ADDENDUM NO. 4

**#15036 – FORD FIELDS CONCESSION STAND
BEAUMONT, TEXAS**

**RENOVATION TO
 FORD FIELDS
 CONCESSION
 STAND**
 5115 IH-10 SOUTH
 BEAUMONT, TX. 77705

1
SK-2

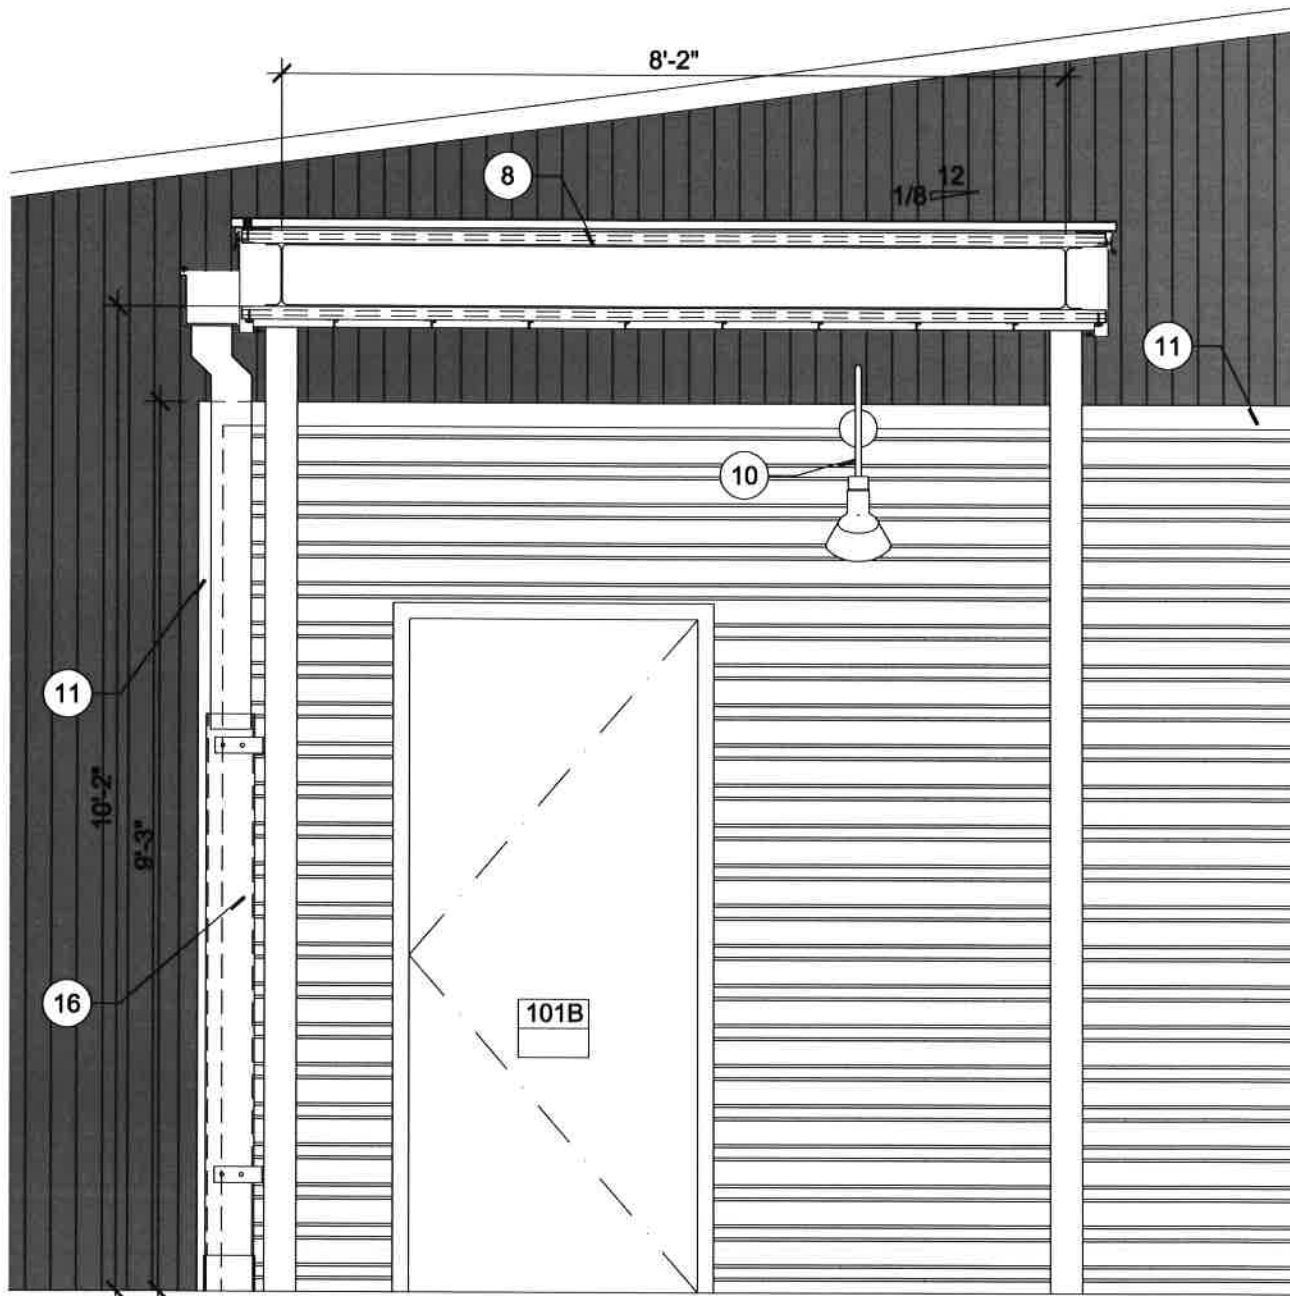
1. SK-2 shall be included on A3.0 as an enlarged section of the Covered Walkway shown on 4/A3.0
